PROCELTEK
 Prestressed Concrete Solutions

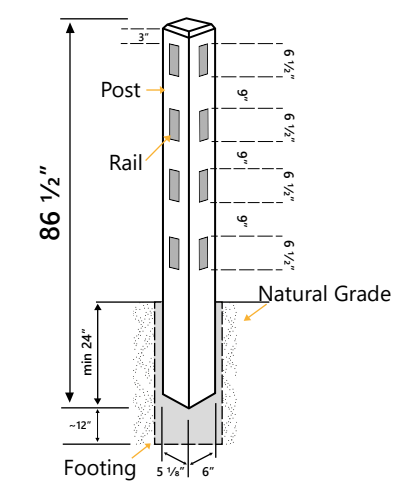
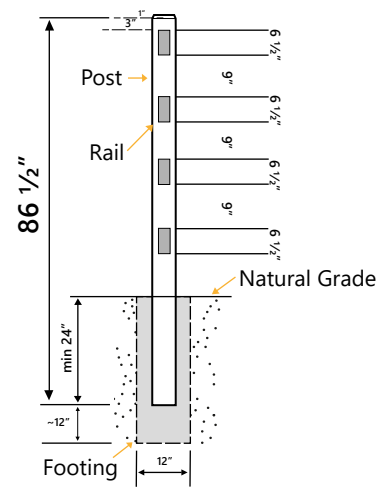
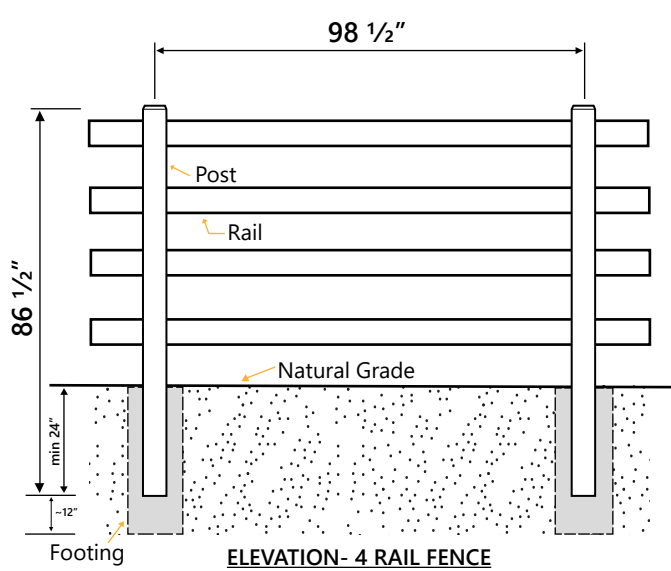
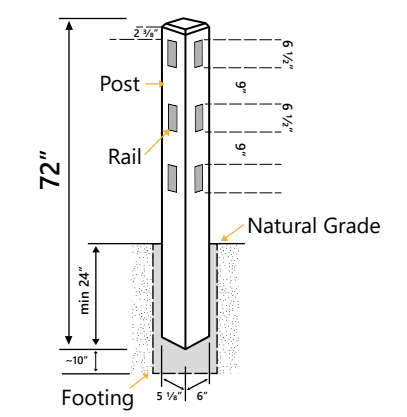
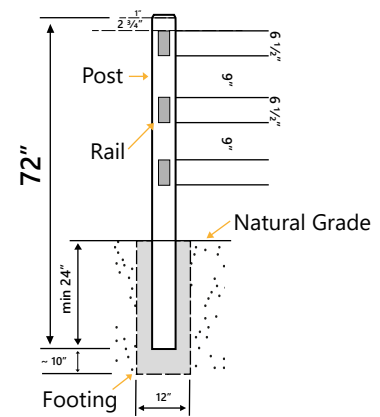
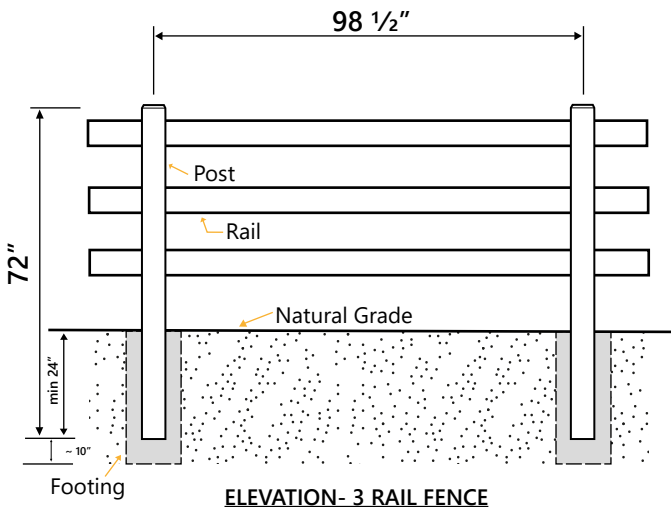
The concrete panel need to be at least 1 3/16" inside the post on each side.
